April 2025

PR24 redeterminations

Expenditure allowances – cost adjustment claims

Figure 1: Leakage spend per property vs leakage levels per property

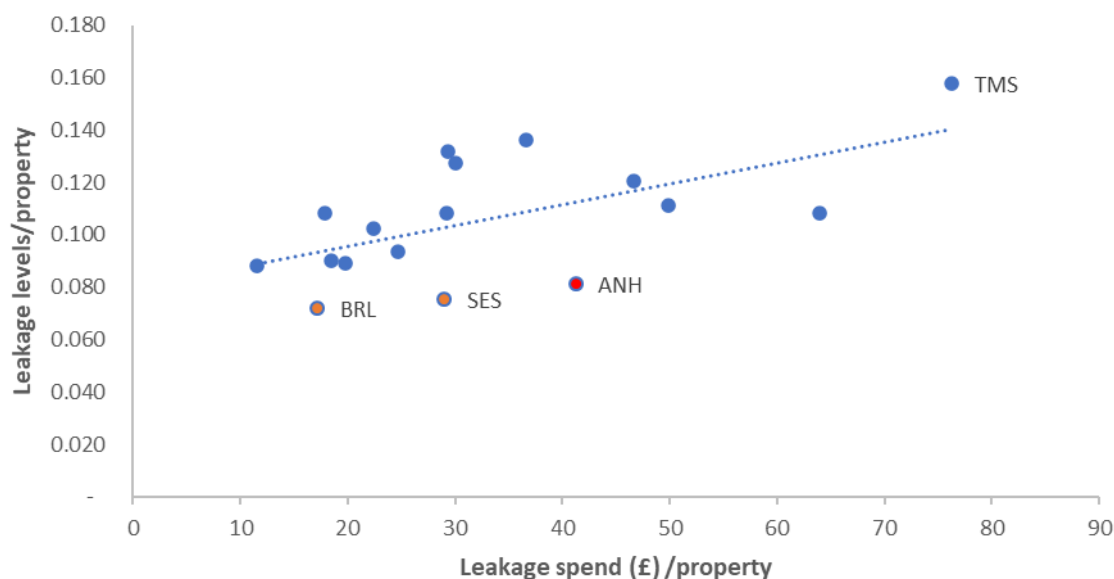
- 2.18 Therefore, we consider that the leakage cost and performance data does not provide compelling evidence to show that companies with lower levels of leakage (per property or length of mains) incur higher leakage costs (per property or length of mains) than companies with higher levels of leakage.

Figure 5: Northumbrian Water deterioration modelling outputs

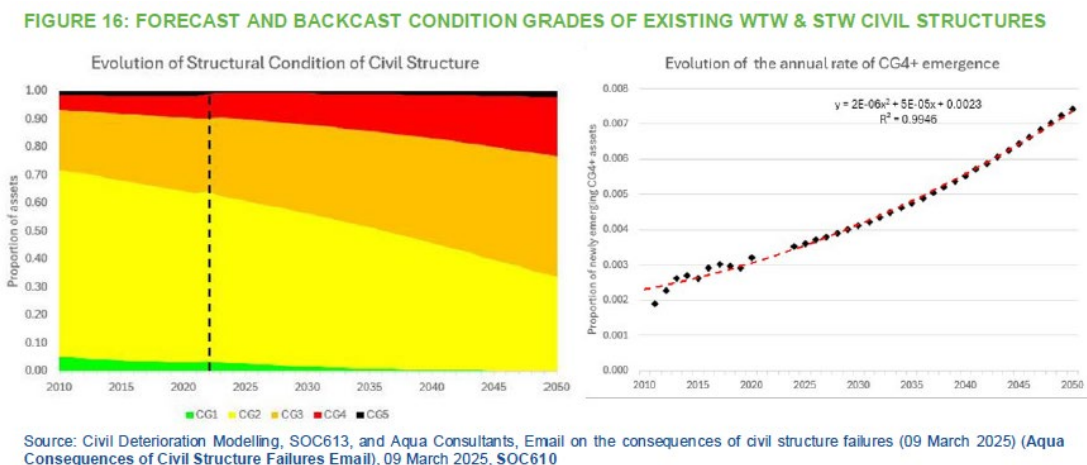
- 5.19 Northumbrian Water has also developed deterioration modelling. It states that its models show that the number of assets entering condition grade 4 and 5 is increasing above what has been observed historically.⁴⁵

- 5.20 The deterioration model is based on asset inspections in 2022–2023, combined with the year the asset was installed. This indicates that the company has not been collecting data on the condition of their assets over time, and therefore may not have had a good understanding of

- 5.21 Firstly, the deterioration model is built using a single inspection at each asset in 2022-2023, rather than tracking the cohort of assets over time. The deterioration analysis is therefore sensitive to inaccuracies in year of construction, for which no evidence of assurance has been provided.
- 5.22 Secondly, the deterioration analysis is sensitive to the sample of asset used, and the company's operating conditions and maintenance history (or absence of maintenance). No evidence has been provided on how the sample of assets was selected.
- 5.23 Finally, the model does not show good correlation with the observed data, particularly for concrete sewage treatment works, the most common asset type, where the model overpredicts the proportion of treatment works asset at condition grades 4 and 5 (red)⁴⁶.

Figure 7: Base capital maintenance expenditure relative to total network length

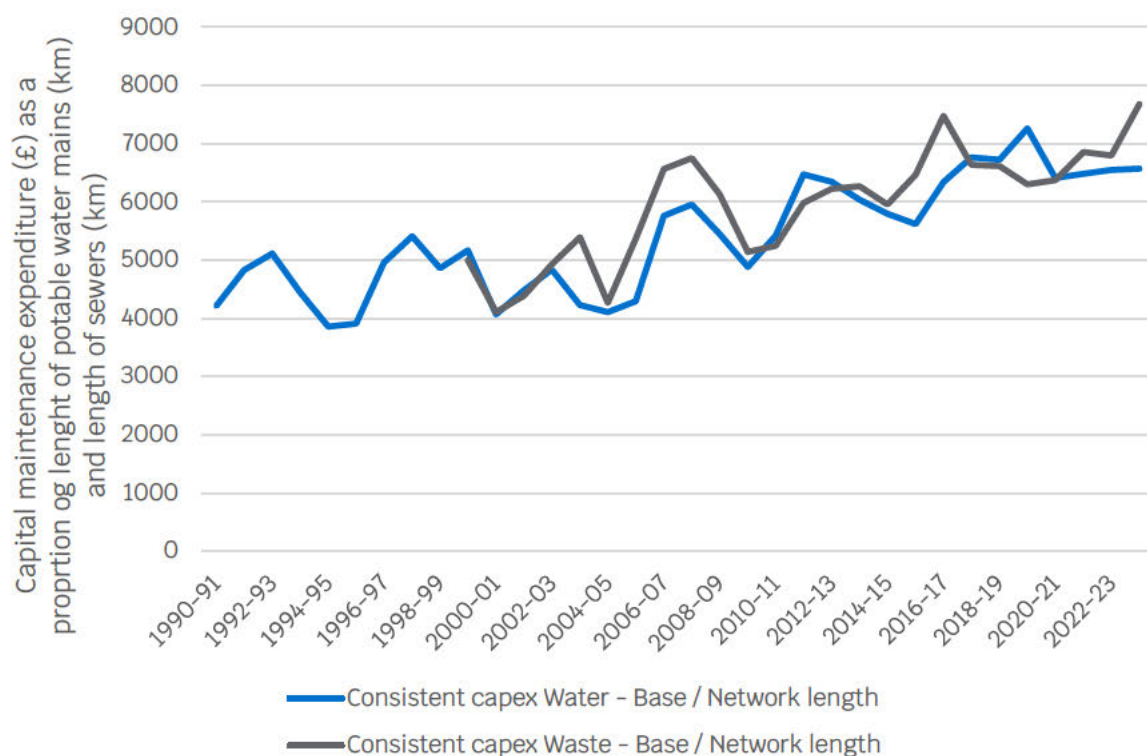
- 5.48 We have also looked at base capital maintenance expenditure as a proportion of network length to understand how this has increased as the asset base has grown. As demonstrated in Figure 7, this has increased over the historical period representing an average increase of 2% for water and 3% for wastewater

- 5.49 We still consider that Northumbrian Water is sufficiently funded to deliver its required capital maintenance investments across the 2025-30 period. At final determination, the company's base expenditure allowance was 11% higher than at PR19, 4.8% (£179 million) below its draft determination representations proposal, and only 1.8% (£64 million) below its original business plan. The company's base cost challenge was no greater than the sector average base cost gap. This demonstrates that we have recognised the need to increase base capital maintenance allowances and as a result ensured that companies' can deliver the required capital maintenance.

Figure 86: Northumbrian Water total capital expenditure

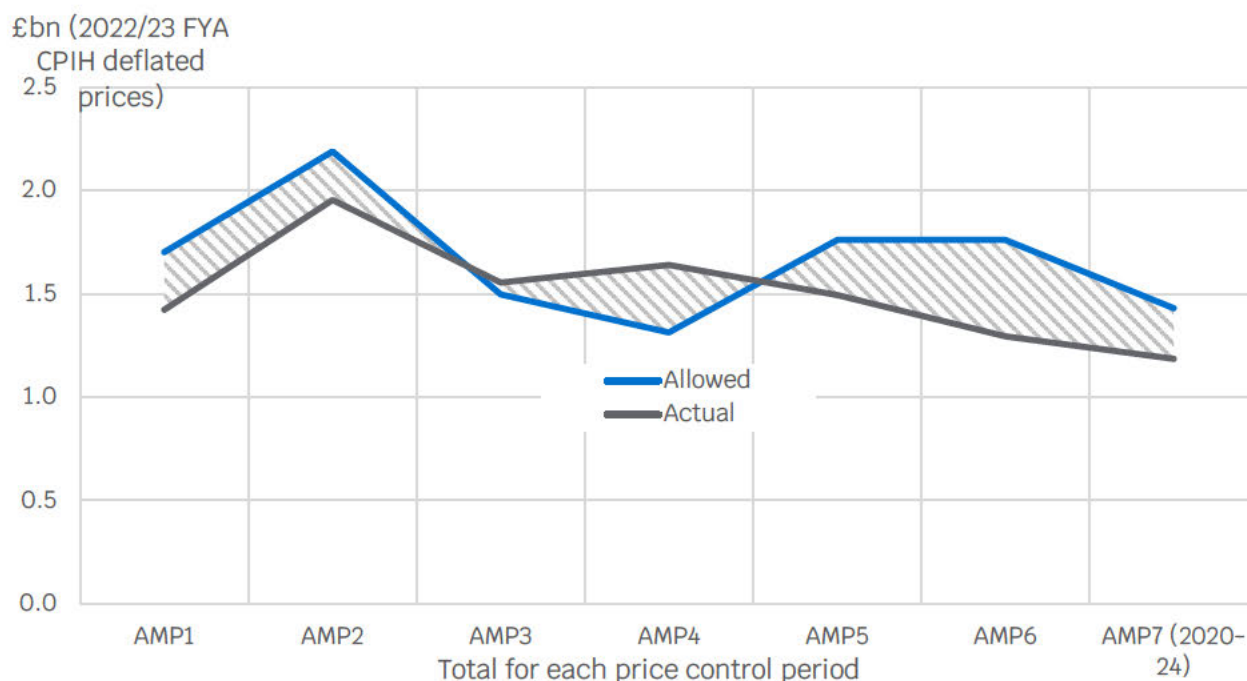
- 5.53 Our analysis shown in Figure 8 demonstrates that Northumbrian Water have historically underspent their total capital expenditure allowance with a cumulative underspend of £1.1 billion. We provide long term allowances and expect companies to manage peaks and troughs in capital maintenance over the long-term. While historical capital expenditure data does indicate that companies have overspent on base, it shows significant underspend on enhancement in each regulatory period.
- 5.54 Coupled with this, we have found no written record of companies highlighting or raising concerns with underfunding in earlier regulatory periods. We therefore consider it is possible that there is a risk of cost allocation issues over time within the capex allowance envelope, which is being inaccurately represented at PR24.

Figure 12: Southern Water advanced anaerobic digestion upgrade implicit allowance calculations illustration

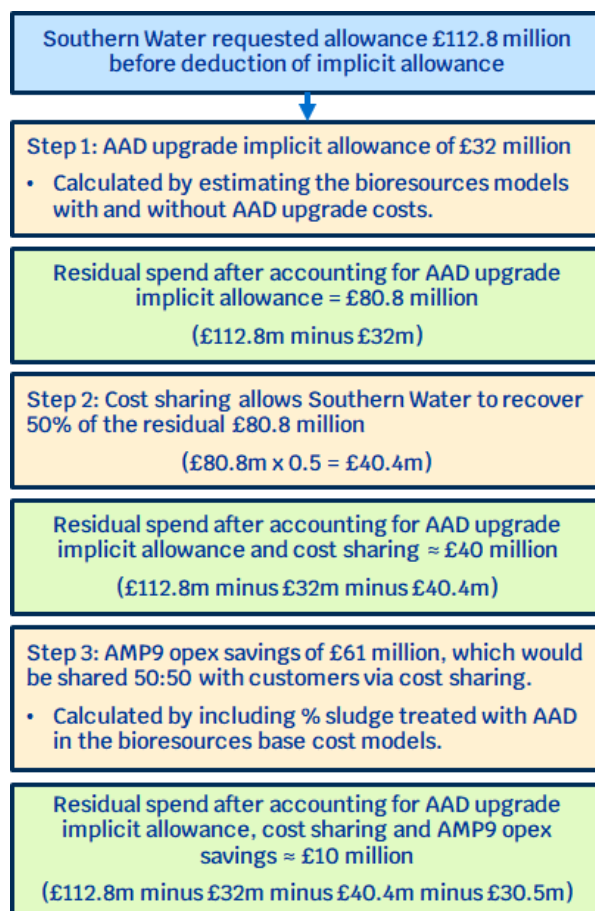
- 6.28 The residual cost facing Southern Water for the AAD upgrades after accounting for all three elements (AAD upgrade implicit allowance; 2030-35 opex savings; and cost sharing) is around £10 million. This is conservative as it only accounts for opex savings in one regulatory period when the asset life of the AAD assets exceeds 20 years,¹¹¹ and does not account for implicit allowances it has received to deliver AAD upgrades in previous regulatory periods but has actively chosen not to.

Figure 14: Unit cost by company for coastal and inland large sewage treatment works

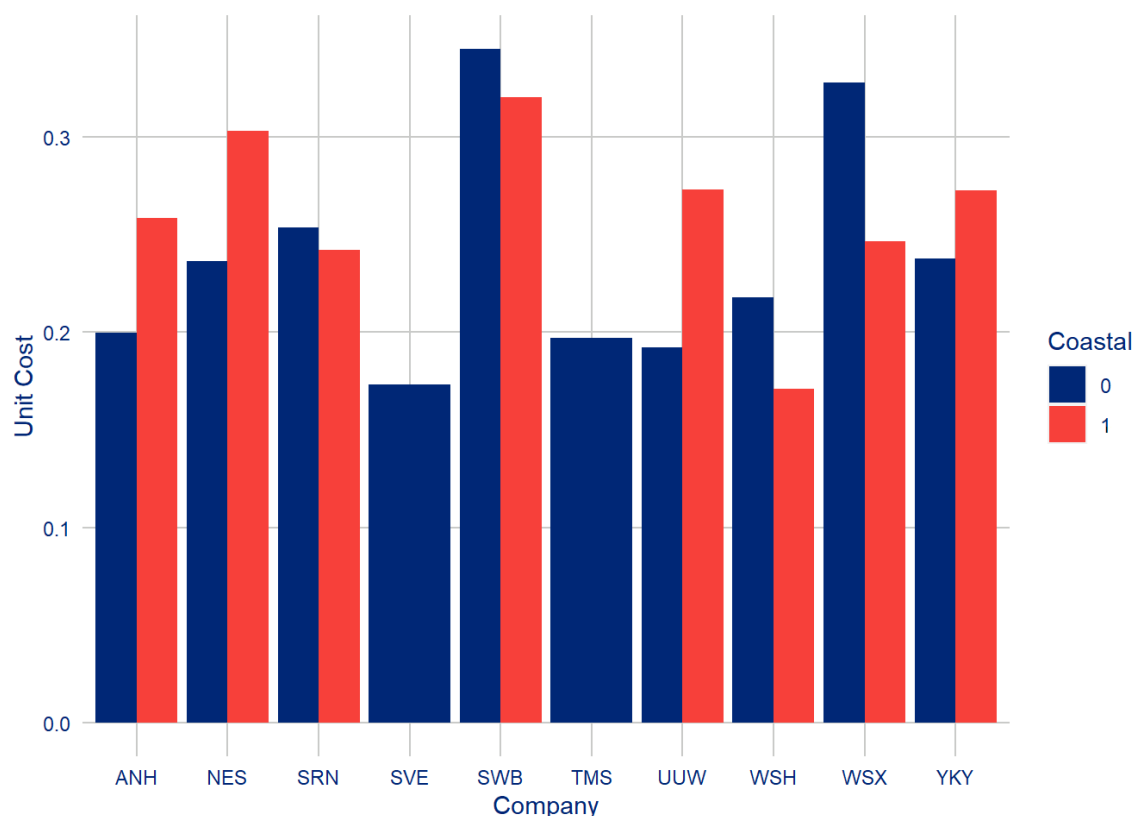
- 8.24 We find average unit costs (weighted by load) for inland sites are higher than for coastal sites for Southern Water, South West Water, Dŵr Cymru and Wessex Water. These companies treat the majority of load through coastal plants and are in fact, the companies with the largest proportion of load treated at coastal plants in the industry.

Figure 158: Unit costs versus load for coastal and inland sewage treatment works

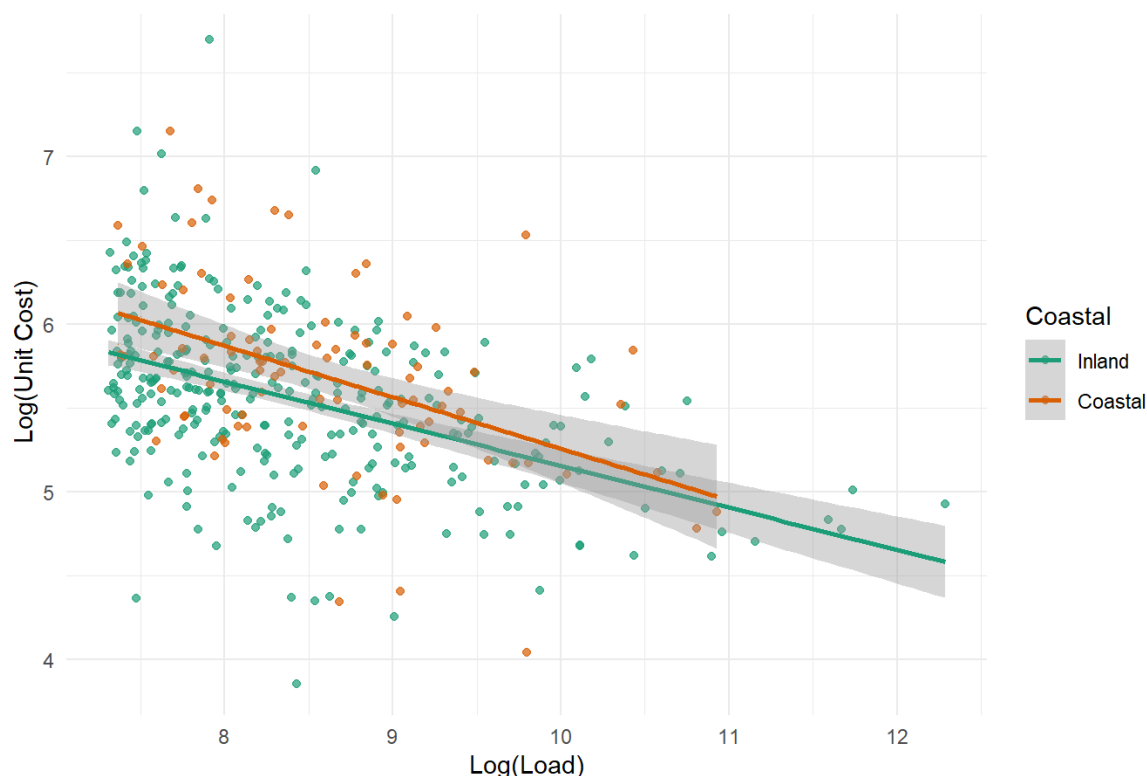
8.28 Overall, these findings suggest that coastal location may not be a meaningful driver of unit cost differences at sewage treatment works once economies of scale are accounted for.
